Access Compliance Report

Public Rights-of-Way

(Curb Ramps)

Intersection ID: 11174	Main Street: HARRISBURG_RD	Cross Street: TIMBERTOP_LN	Location: NW
ADA ID: DC95313153EC	Ramp Type: Perp	Initial Pass/Fail: Fail	Overall Compliance: No
Severity Score: 13.75			
Codes/Mitigation Info/Possible Solution		Field Measurements/Component Compliance

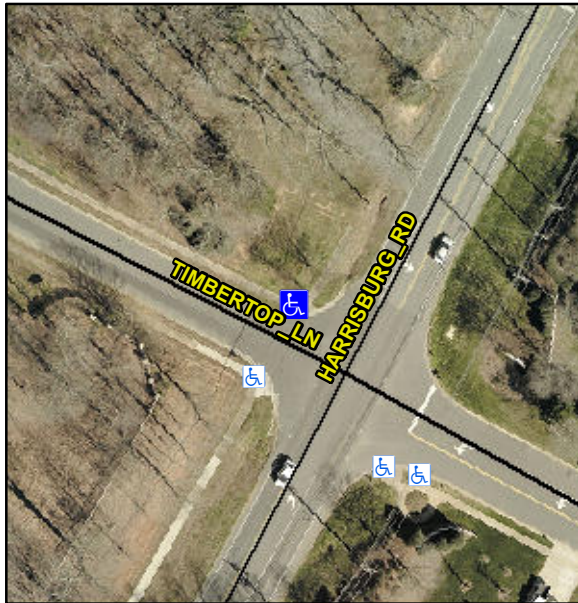
Not Found, R304.2.2, R304.5.3

Compliance	Description	Data	Compliance	Description	Data
N/A	Ramp Length (in)	51.0	No	Ramp Slope (%)	9.1
Yes	Ramp Width (in)	48.0	No	Ramp XSlope (%)	3.6
N/A	Flare Type LT	N/A	N/A	Flare Type RT	N/A
N/A	Flare Slope LT (%)	N/A	N/A	Flare Slope RT (%)	N/A
N/A	Flare Traversable LT?	N/A	N/A	Flare Traversable RT?	N/A
N/A	Landing Length (in)	N/A	N/A	DWS Provided?	N/A
N/A	Landing Width (in)	N/A	N/A	DWS Contrast?	N/A
N/A	Landing Slope (%)	N/A	N/A	DWS Length (in)	N/A
N/A	Landing X Slope (%)	N/A	N/A	DWS Full Width?	N/A
N/A	Landing Curb? (Y/N)	N/A	N/A	DWS Offset (in)	N/A
N/A	Shared Landing?	N/A			
N/A	Gutter Ponding?	N/A	N/A	Gutter Slope (%)	N/A
N/A	Gutter Lip Ht (in)	N/A	N/A	Gutter X Slope (%)	N/A
N/A	Painted X Walk1?	No	N/A	Painted X Walk2?	N/A
	X Walk 1 Direction	To S		X Walk 2 Direction	N/A
N/A	X Walk 1 Width (in)	N/A	N/A	X Walk 2 Width (in)	N/A
	X Walk 1 Slope (%)	3.7		X Walk 2 Slope (%)	N/A
	X Walk 1 X Slope (%)	1.8		X Walk 2 X Slope (%)	N/A

Remove & Replace Entire Ramp.
